FIRST FIVE-YEAR REVIEW REPORT
FOR
DEVENS RESERVE FORCES TRAINING AREA
DEVENS, MASSACHUSETTS

U.S. Army Corps of Engineers
New England District
Concord, Massachusetts

Harding Lawson Associates
Portland, ME
Project No. 45227
Task No. 0993804

**RESPONSE TO COMMENTS
ON THE DRAFT FIRST FIVE-YEAR SITE REVIEW REPORT
FOR THE DEVENS RESERVE FORCES TRAINING AREA
DEVENS, MASSACHUSETTS**

9-2

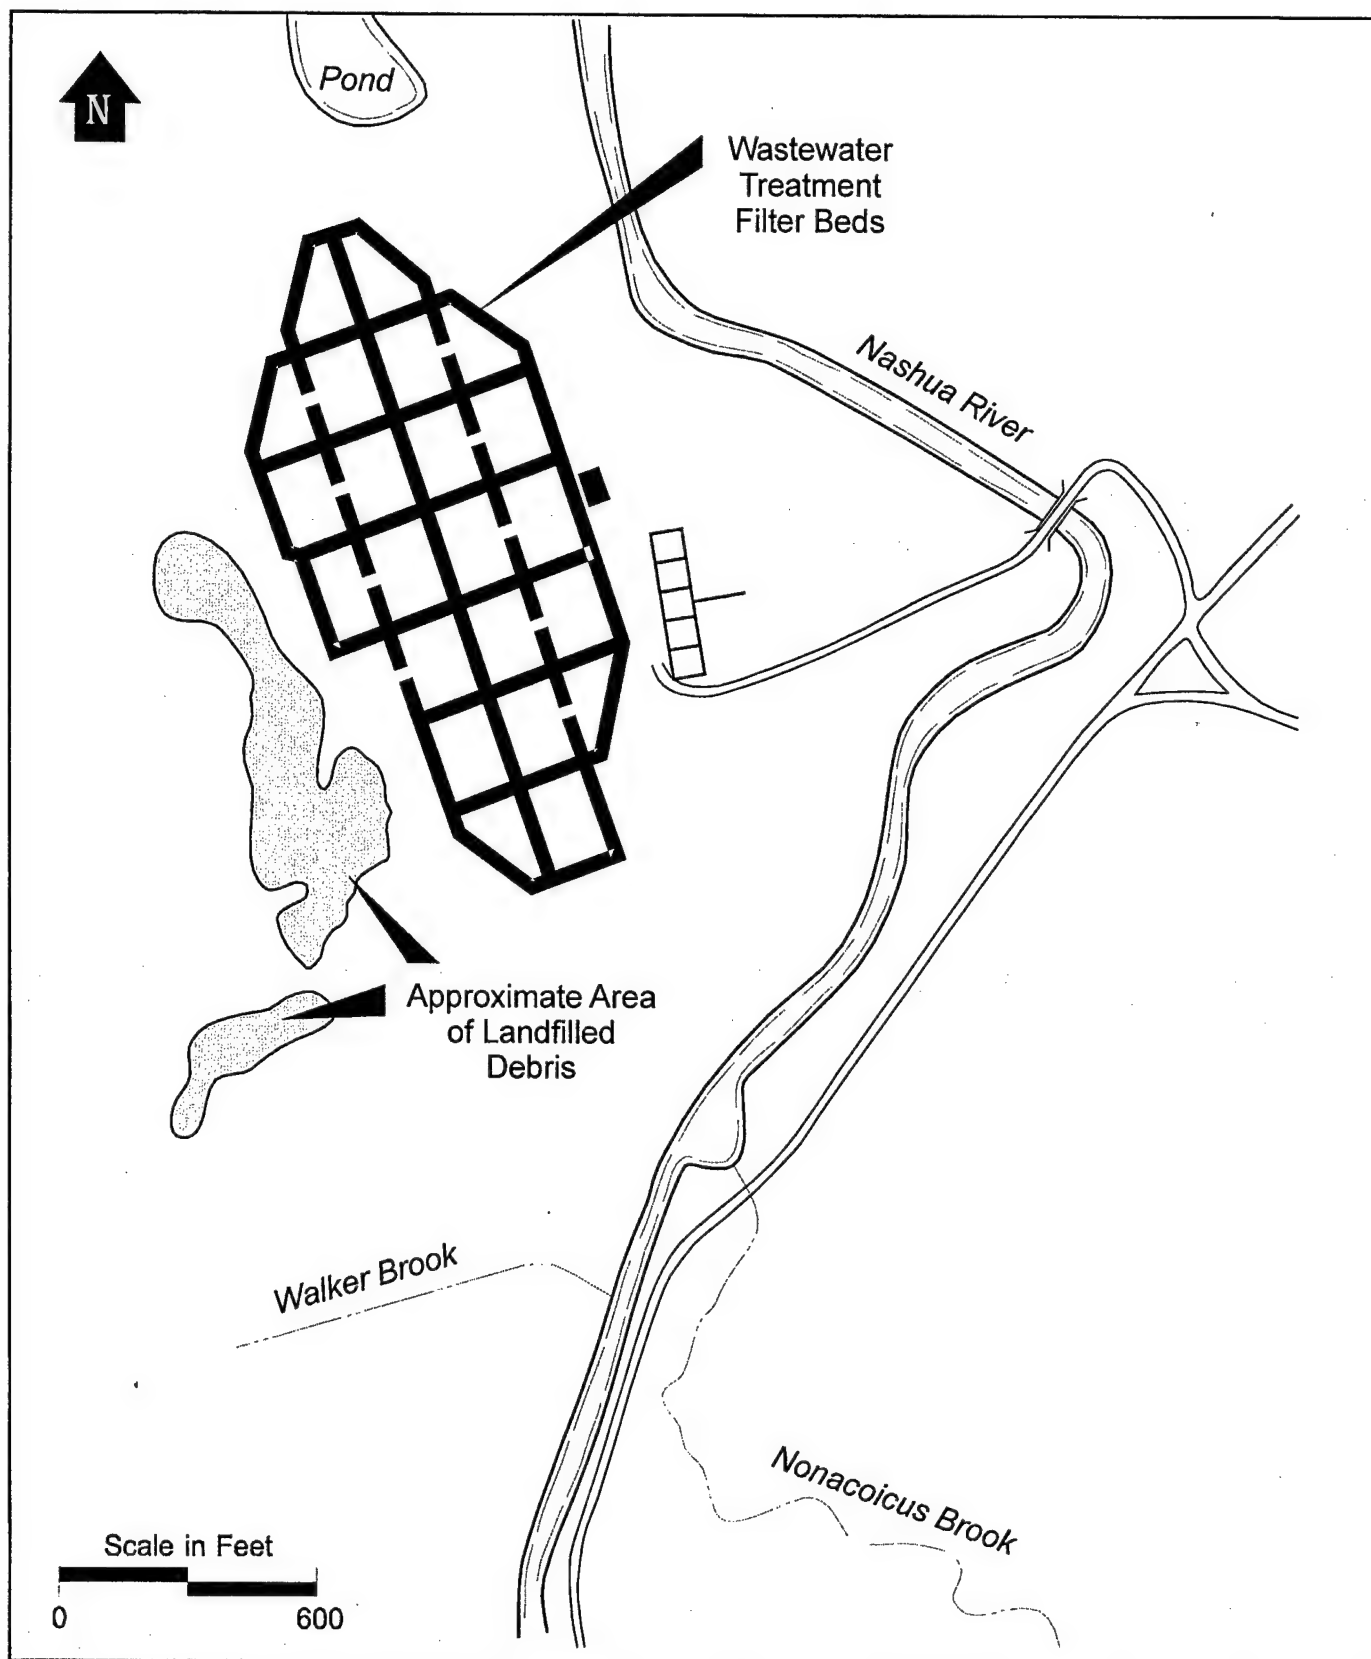
48. Comment: Figure 9-2 - *typo*: Change "Nashus River" label to "Nashua River."

Response: The requested spelling correction has been made to Figure 9-2.
